RECALL H514 - HIGH VOLTAGE BATTERY PACK THERMAL OVERLOAD – USA ONLY

SAFETY RECALL H514 – HIGH VOLTAGE BATTERY PACK ASSY THERMAL OVERLOAD - USA

AFFECTED MODELS	19MY I-PACE
VOLUME AFFECTED	US 2760
REPAIR	Vehicles recalled as part of the H441, H459 or H471 safety recalls have subsequently experienced thermal overload. The diagnostic software updates have been identified as not providing an appropriate level of protection for the 2019MY vehicles in the USA. As an interim measure, recalled vehicles will receive a software update that will alter the maximum state of charge of the EV battery to 80%. A permanent remedy is under development and will be notified in due course when available.
REPAIR TIME	0.3 hrs + DIDO
CAMPAIGN LAUNCH	Retailer Admin Notification bulletin was published on September 6th, 2024. Software availability and interim recall repair publication was on October 18, 2024. Clients were mailed a 2 nd notification on November 6 th , 2024.advising that interim repair appointments should be made.
NOTES	IMPORTANT! The only valid repair procedure is to run the special application hyperlink in the bulletin procedure. To date, 34 vehicles closed in this recall have not had the in

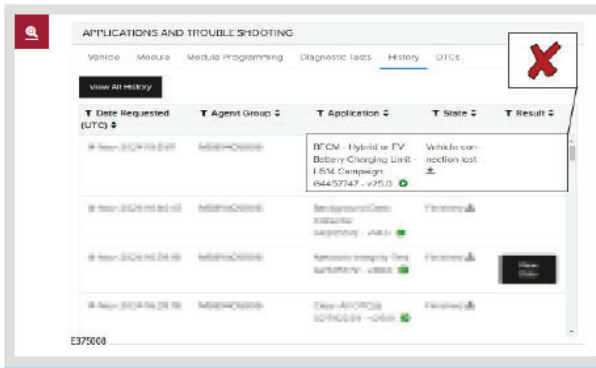
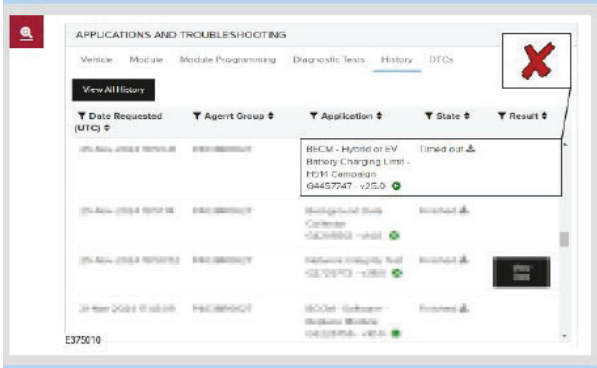
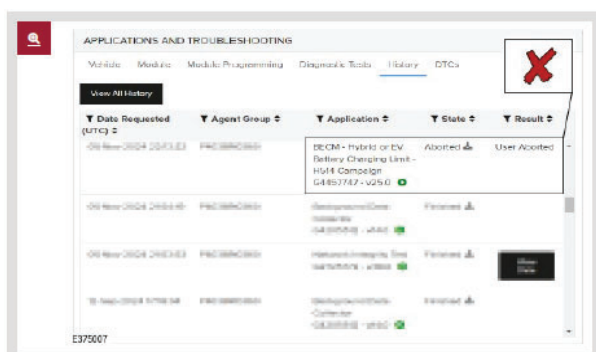
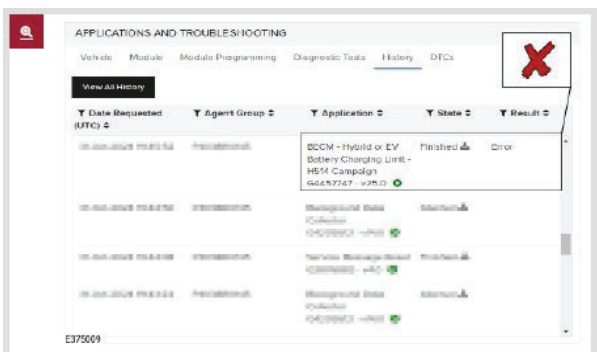
H514 Recall Bulletin was republished as v4 Dec 9th 2024 with additional Diagnostic Information showing some of the incomplete repairs performed. Bulletin extracts below.

Repair Completed correctly
